Application No. 10/708,658 Amdt. Dated May 1, 2005

Reply to Office Action of February 1, 2005

Amendments to the Drawings:

FIG. 13D

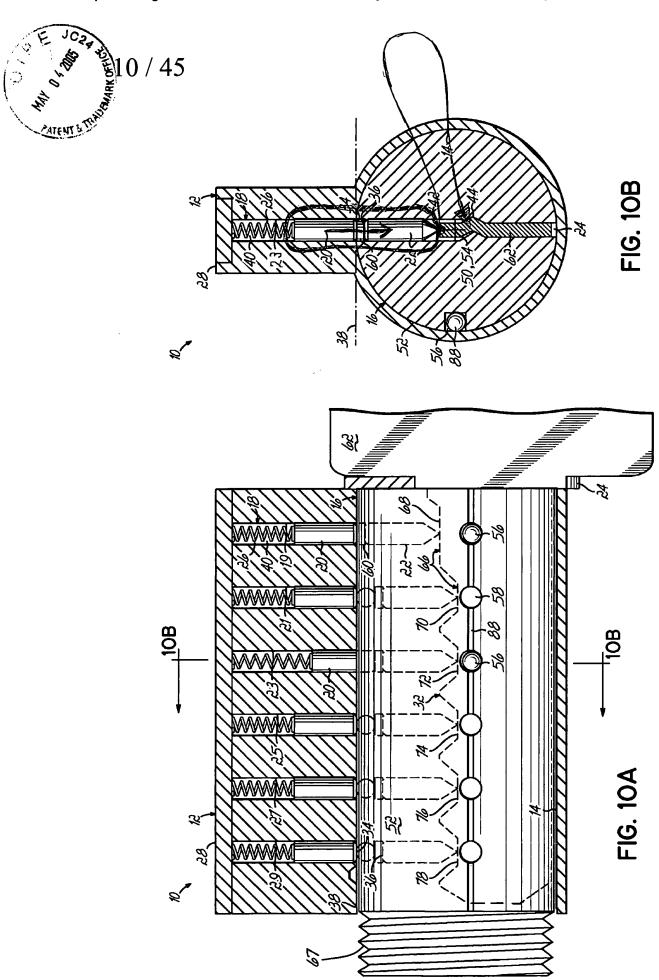
Fig. 13D has been corrected to change the key reference number "84" to -- 86 --, as

described in para. 0139.

FIG. 44B

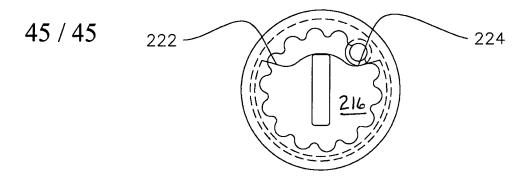
Fig. 44B has been corrected to add lead line and reference number 216.
